**Preliminary Comments on
DOE Draft SEIS
for Yucca Mountain &
Draft Nevada Rail Corridor SEIS
and Rail Alignment EIS**

Bob Halstead
Nevada Agency for Nuclear Projects
US DOE Public Hearing
Caliente, Nevada
November 15, 2007

Potential Rail Routes to Yucca Mt. via Proposed Caliente Spur (Suite of Routes from Kansas City and Memphis Gateways)

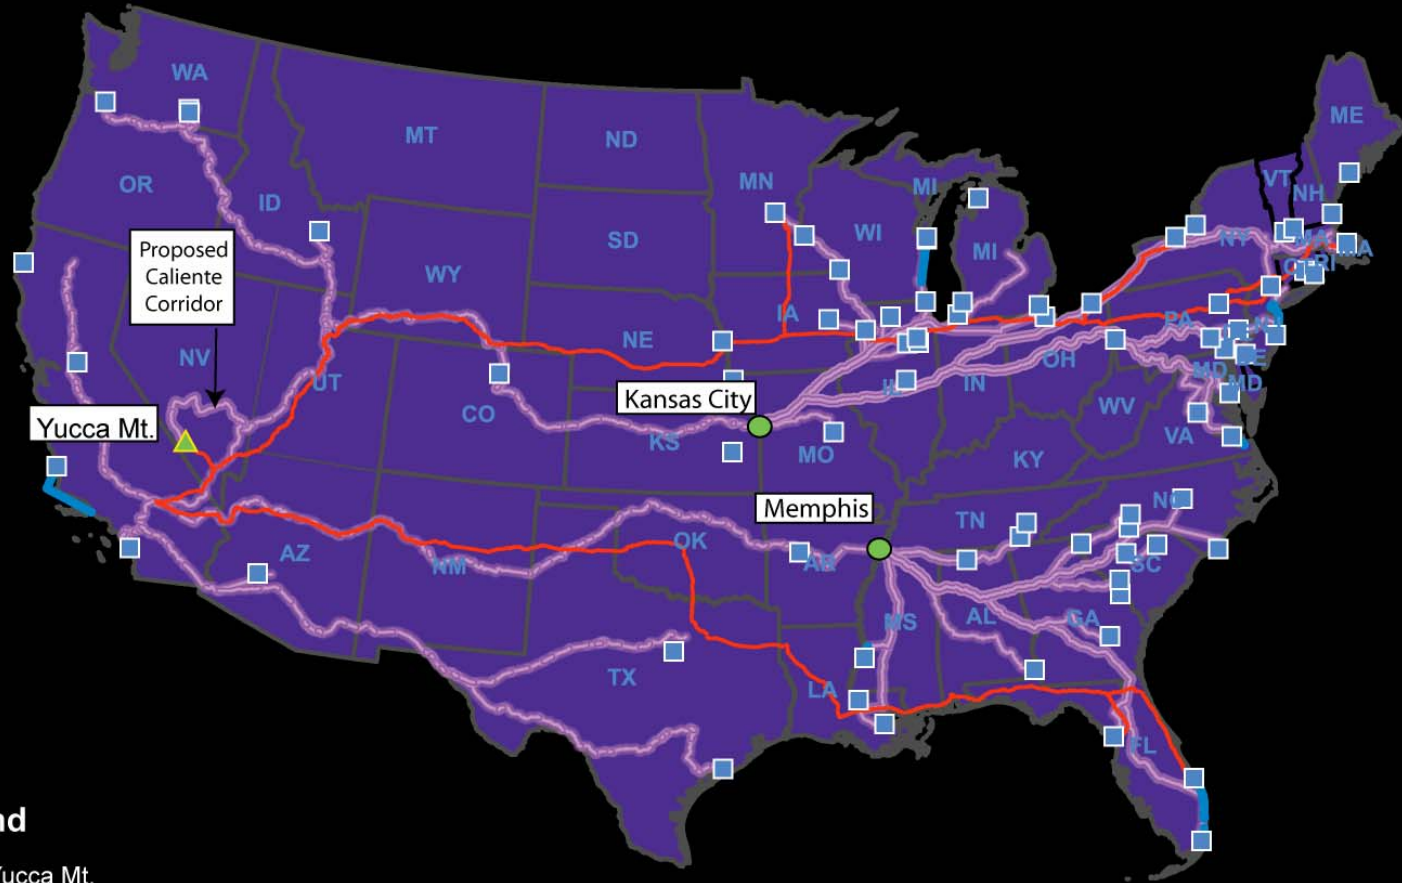
DEISs Show “Representative Routes” for Rail and Truck Shipments to Nevada

- Rail routes shown in DEISs do not include those already identified by Union Pacific and BNSF as “preferred routes” to Caliente
- Highway routes shown in DEISs are for the most part the same routes identified by Nevada
- Rail shipments via Caliente would traverse downtown Las Vegas
- Truck shipments to Yucca Mountain would traverse Las Vegas metro area
- Map prepared by Nevada more accurately depicts rail routes that DOE would actually use
